■ Letter 47: California State Parks Foundation (1/12/10)

Candlestick Point — Hunters Point Shipyard Phase II EIR
CPSRA AND PROJECT BOUNDARIES

FIGURE C&R-8

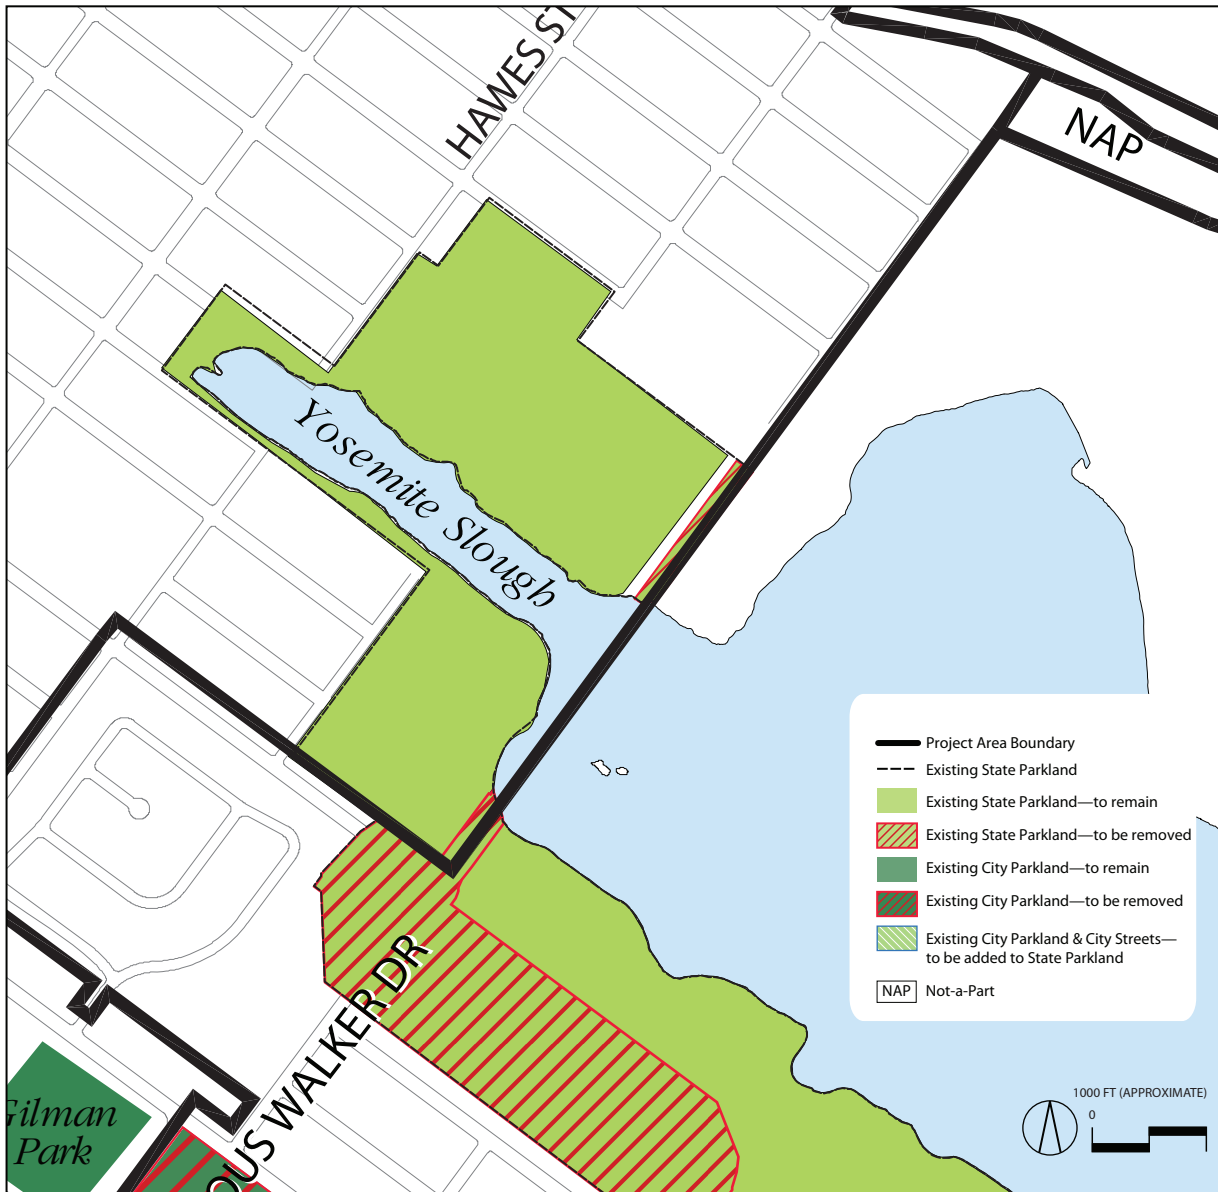
Response to Comment 47-4

The figures in the EIR depict the location of the proposed Yosemite Slough bridge relative to the Project site boundaries and the CPSRA. In response to this comment, Figure C&R-8 (CPSRA and Project Boundaries) is provided as a larger-scale depiction to illustrate the Project boundaries relative to the slough. This illustration also clearly shows the proposed position of the bridge relative to the CPSRA boundary. The bridge footings on either side of Yosemite Slough would require removal of portions of parkland from the CPSRA (red hatched areas). On the north side of the slough, this would result in 0.8 acre, and on the south side of the slough it would be part of 2.6 acres that would be reconfigured. As evident in the figure, on the north end of the slough, the bridge footings on the north are located at the eastern edge of the park boundary and thus would not "split" the CPSRA. On the south end of the slough, the area removed for bridge footings would impinge on approximately 300 feet or less (270 feet) through the CPSRA. On the south side, the bridge would extend Arelious Walker Drive through a portion of the CPSRA. Persons using the Bay Trail would be able to cross Arelious Walker Drive and easily access the opposite portion of the CPSRA. Thus, while the road and bridge approach on the south side of the slough would cross the CPSRA, it would not act as a physical barrier preventing use of the entire CPSRA. While the proposed road and bridge would cut through the open space in one location, the majority of the restored slough area would remain unaffected and available for its intended use. Further, given the limited automobile use of the bridge (during stadium events only) crossing Arelious Walker Drive would not involve navigating a heavily traveled thoroughfare. Cross-traffic, except on stadium day events, would be limited to the BRT, bicycles, and pedestrians. The current condition of the

FIGURE C&R-9

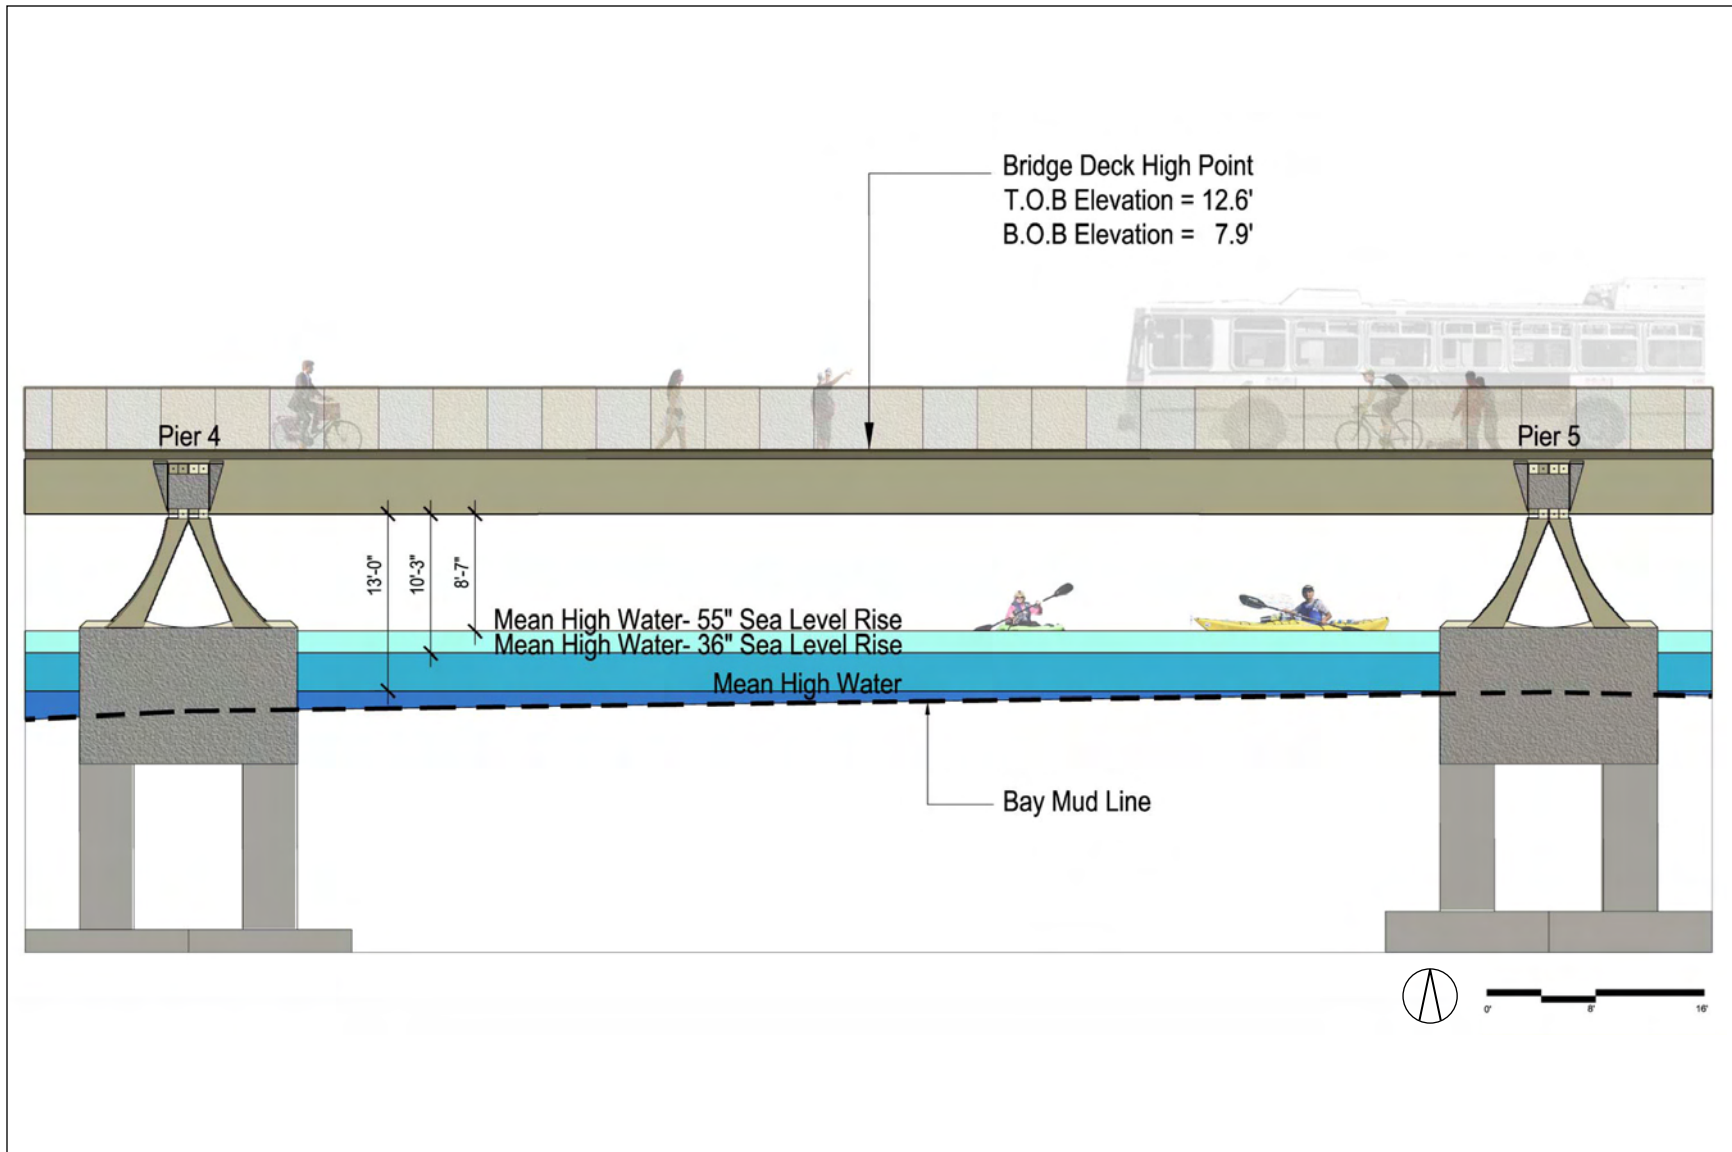
Response to Comment 47-20

The proposed bridge across Yosemite Slough would not impede the passage of recreational paddle crafts from the slough into the open bay. Although the precise details of the bridge's design have not been finalized at this time, preliminary plans estimate that under current conditions, the bridge would provide approximately 13 feet of clearance at mean high water—that is, during an average high tide, as illustrated by Figure C&R-9 (Yosemite Slough Bridge—Paddle Craft Clearances). This is sufficient clearance to allow unimpeded navigation by human-powered craft. If sea level rises by 55 inches—a projection at the high end of many estimates of the effects of climate change—clearance would be 8 feet, 7 inches at mean high water, which is still sufficient for paddle craft navigation. And in a more moderate sea level rise scenario of 36 inches, clearance would be 10 feet, 3 inches at mean high water. Thus, there will be no physical impediment to navigation.

FIGURE III.I-5

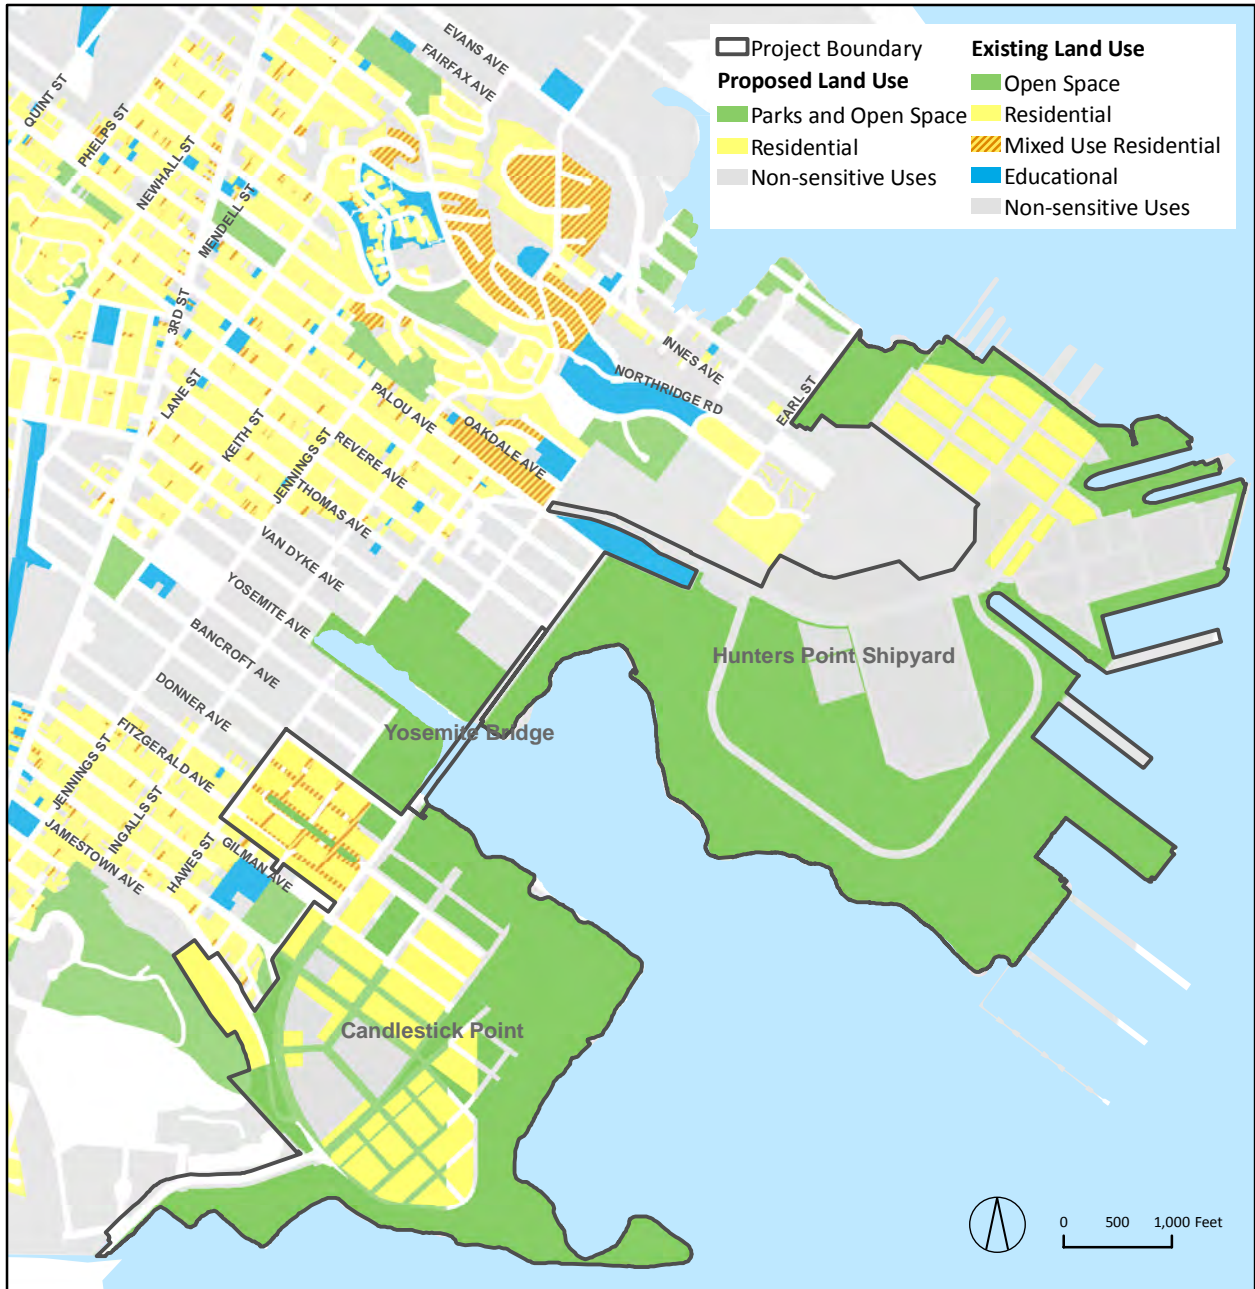
Response to Comment 47-40

As stated in Master Response 3 (Impacts of the Project on Yosemite Slough [Biological Resources]), ambient noise levels at Yosemite Slough are currently high, due to the industrial and storage uses of the properties on the south side of Yosemite Slough (that are outside both the Yosemite Slough Restoration Project area and the CP/HPS project site, and will thus not be subject to change as a result of either project) that are the source of considerable ambient noise. The Yosemite Slough bridge will be used only by BRT buses except during the 10 to 12 days (or if Variant 5 is approved) annually in which vehicles entering or exiting the new stadium will be using the bridge. The hybrid buses that would be used on this BRT route would have a maximum noise level (from pull-away to 35 mph) of 70 to 75 dBA, roughly equivalent to the sound of freeway traffic at a distance of 50 feet. The roadway noise modeling performed for the project in the Draft EIR accounts for the total increase in daily vehicle trips to predict the 24-hour increases in roadway noise levels along existing uses that would potentially be impacted by implementation of the project. Development of the Yosemite Slough bridge would result in BRT buses
